Manor Farm Propco Limited

Manor Farm, Poyle

SLR Project No.: 425.065619.00001

RE: HIGHWAYS S106 DISCUSSIONS – FOOTWAY / CYCLEWAY REQUEST

Figure 1.1 – Extent of Footway/Cycleway Originally Sought

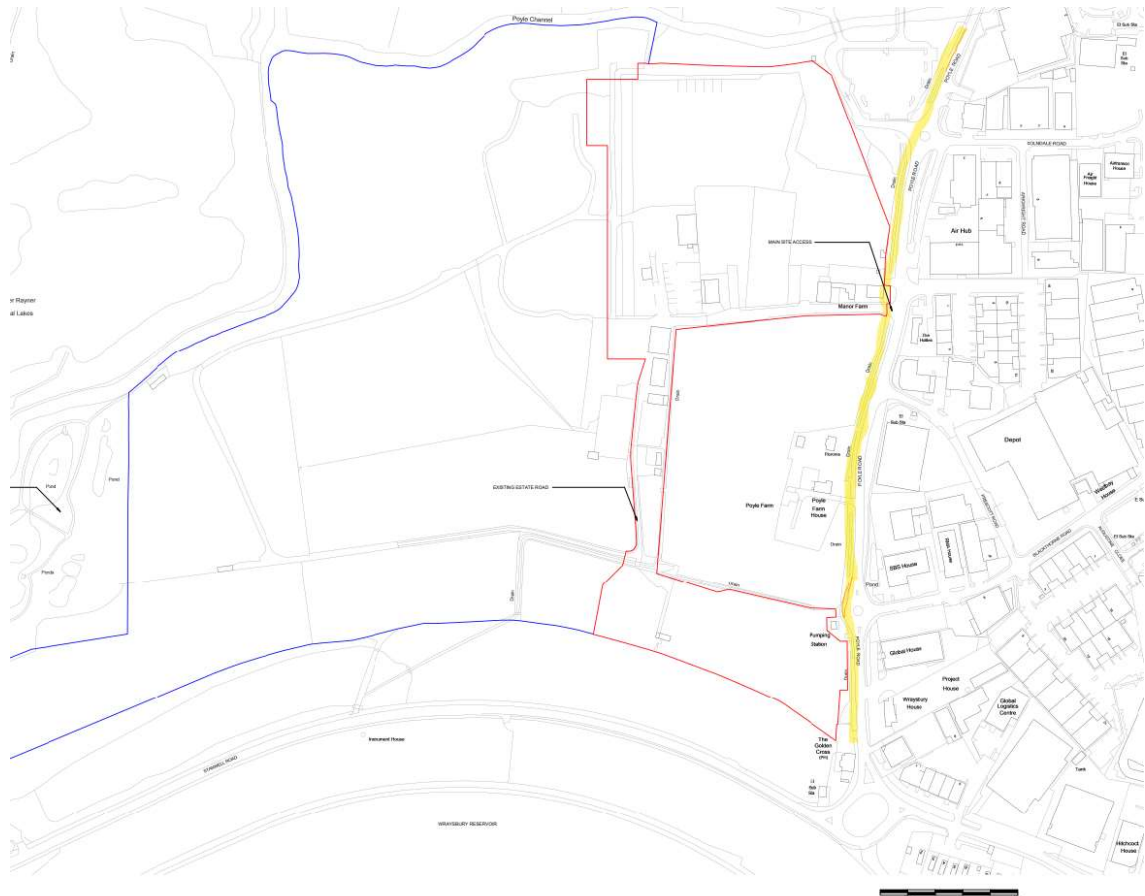
- 1.6 On 13 October 2025 (the day before the public inquiry commenced), SBC confirmed that the extent of footway/cycleway it is seeking is that shown in yellow on Figure 1.1 below. This covers 650m along Poyle Road rather than the 165m appeal site frontage to Poyle Road and extends beyond the Hilton Hotel car park to the north of the appeal site. This extent is referred to in this note as the '*Yellow Footway/Cycleway*'.

Figure 1.2 – Extent of Footway/Cycleway Sought on 20 October 2025

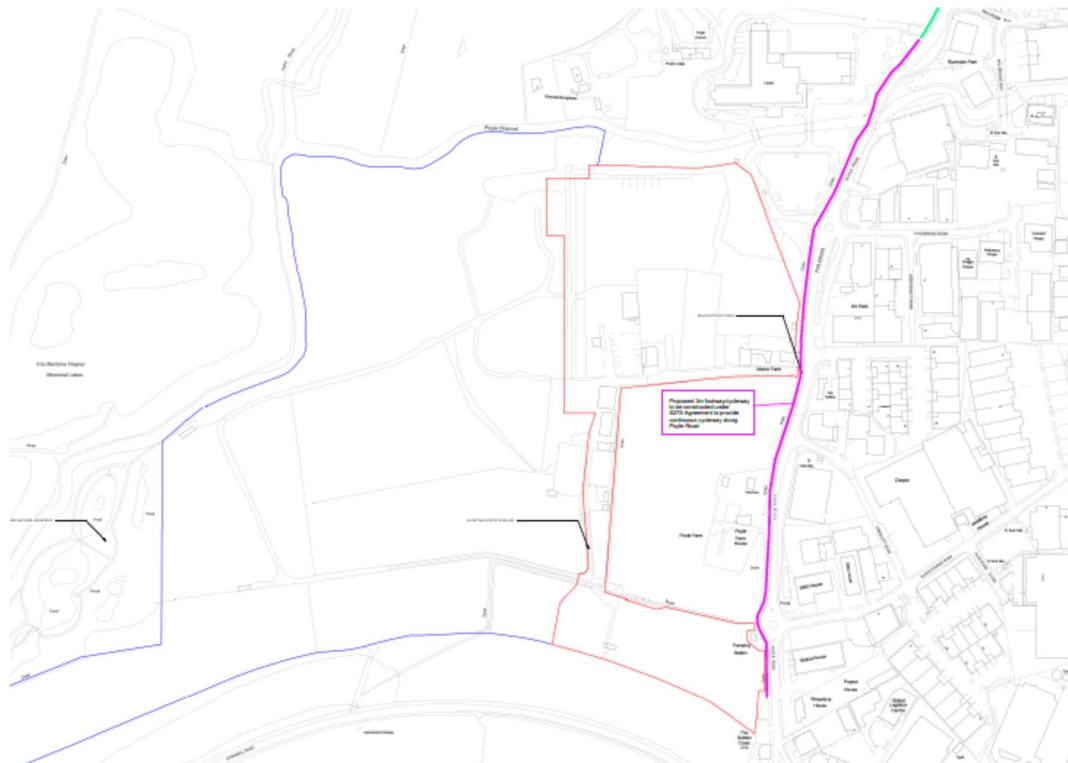
- 1.7 At 4:40 pm on 20 October, SBC revised the extent of the footway/cycleway requested along Poyle Road to that shown in pink on **Figure 1.2**. This covers approximately 790m and extends across Poyle Channel bridge and beyond the Hilton Hotel to the north of the appeal site. This is referred to in this note as the '*Pink Footway/Cycleway*'.

- 2.1 To the north, the requested footway/cycleway cannot be physically accommodated across the Hilton Way junction, or over the Poyle Channel bridge and within the verge on the approach to this bridge from the north.
- 2.2 SLR Drawing 237679/PD14 shows the width constraints at the Poyle Road / Poyle Channel bridge and to the north of the bridge and the existing shared used footway / cycleway. A copy of this drawing is provided in Figure 2.1 below and within **Appendix D**.

- 2.3 With reference to 5.1 of LTN 1/20 below, these widths are far below that required by the kinetic envelope of passing cyclists. Given the length of a reduced width facility could comprise up to 130m, this is considered a safety risk for passing cyclists and pedestrians - and would require cyclists to be put back on carriageway for this 130m extent.

- 2.4 The Pink Footway/Cycleway requested by SBC therefore cannot physically be accommodated. As this cannot be delivered, the rest of this TN considers the Yellow Footway/Cycleway only.

Figure 1.3 – Proposed Footway and Crossing Points

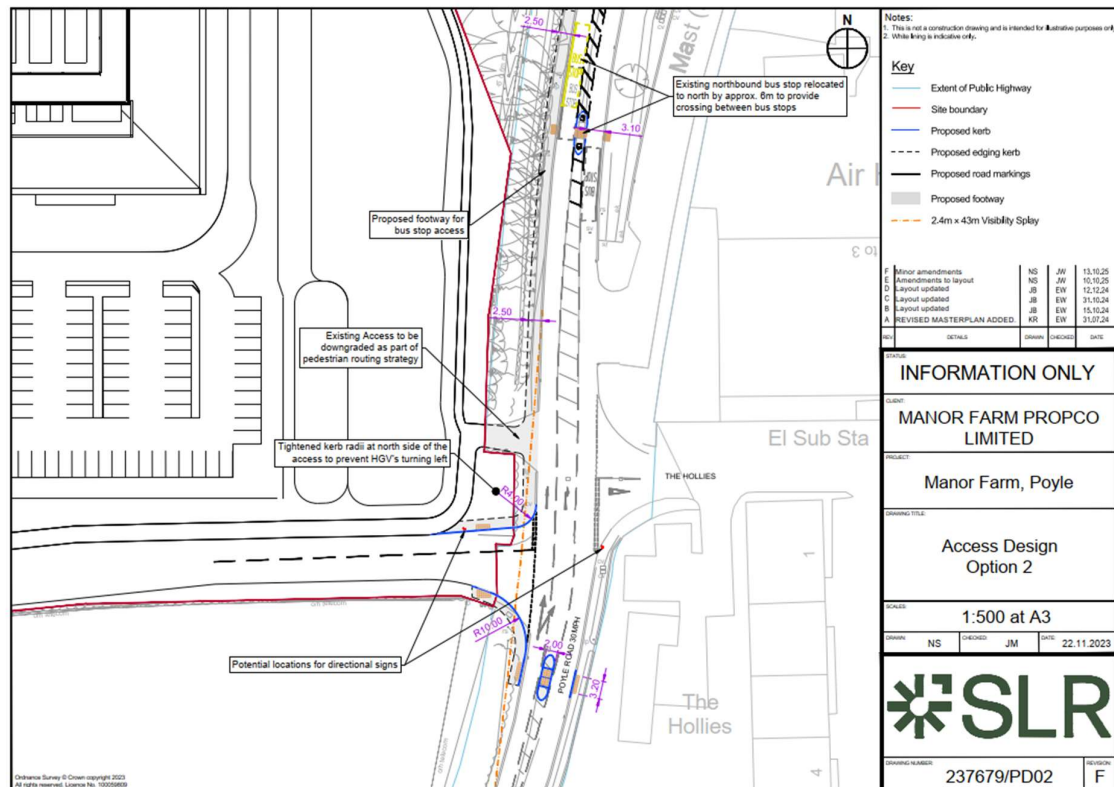
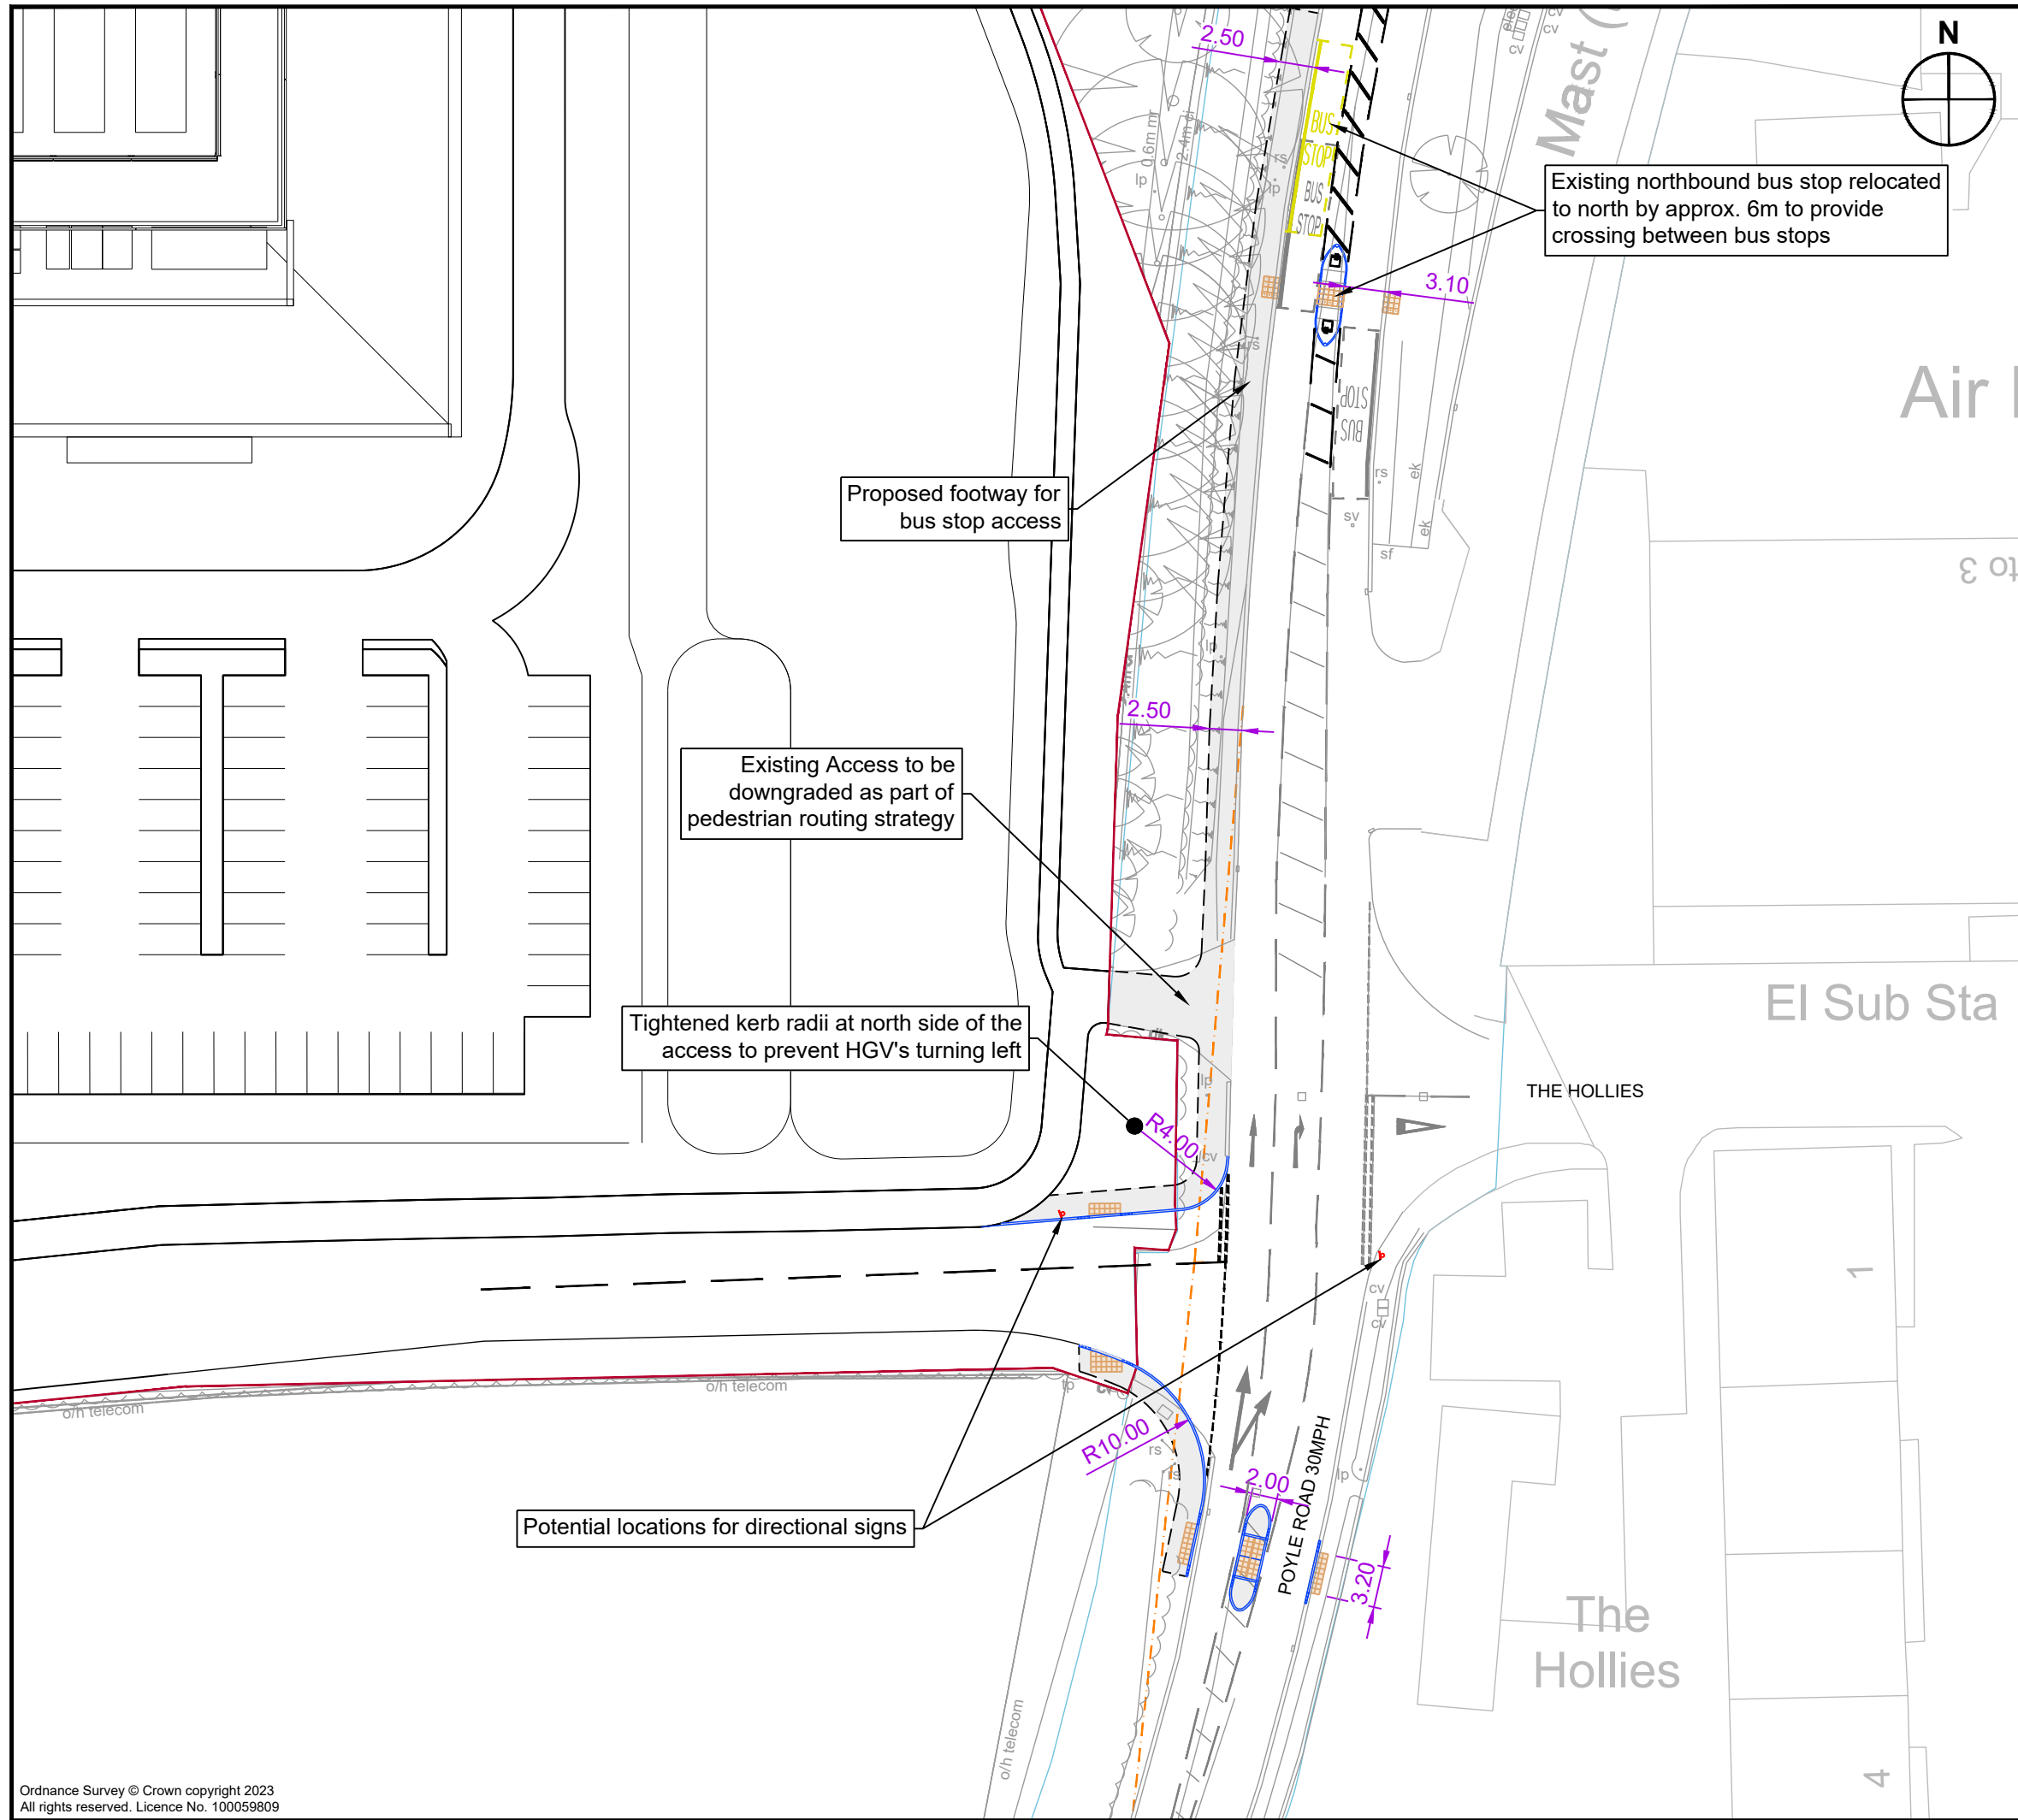
- The exact scope of works has not been discussed or agreed
- P01 – This plan shows an isolated area of highway works relating to the emergency access provisions. Although these works appear to be satisfactory, they do not include the footway/cycleway which we have requested along the frontage of the development site and that would tie into these works.

- P02 – This plan shows a limited amount of highway works. We have requested for a footway/cycleway fronting the site to improve sustainable travel options and to improve access to the site.

- The works shown only link the site to the northern bus stop and therefore only serve bus passengers to/from the site. The works do not encourage walking or cycling and do not provide adequate provision for these users.

- Southbound bus passengers have to walk along a convoluted route which they are unlikely to follow and this would cause them to risk crossing in a less than ideal/safe location to access the site. Likewise pedestrians walking to the site from the north

have not got a ideal route to follow as they have to walk on the opposite footway and cross over beyond the site.

- 1.8 The Appellant is proposing to construct a footway along the frontage of Parcel A, to the northbound bus stop on Poyle Road. It is also committed to providing two crossing points on Poyle Road to the north and south of the main site access¹. These features are shown on **Figure 1.3** below (full size version within **Appendix C**):

- 5.3 There is an existing footway on the eastern side of Poyle Road, and the Development proposals include up to two (the second being subject to a satisfactory Road Safety Audit) safe and inclusive uncontrolled crossing points adjacent to the appeal site access allowing for access across Poyle Road towards the existing footway. These pedestrian crossing points are expected to comfortably accommodate the expected pedestrian flows given the low number of pedestrian movements anticipated to be generated by the site (71 pedestrians on a typical weekday as shown at **Appendix E**).

- 5.4 Pedestrians will access the appeal site via this footway on Poyle Road and the crossings provided. No additional footway is needed to safely accommodate pedestrian flows north or south of the appeal site.
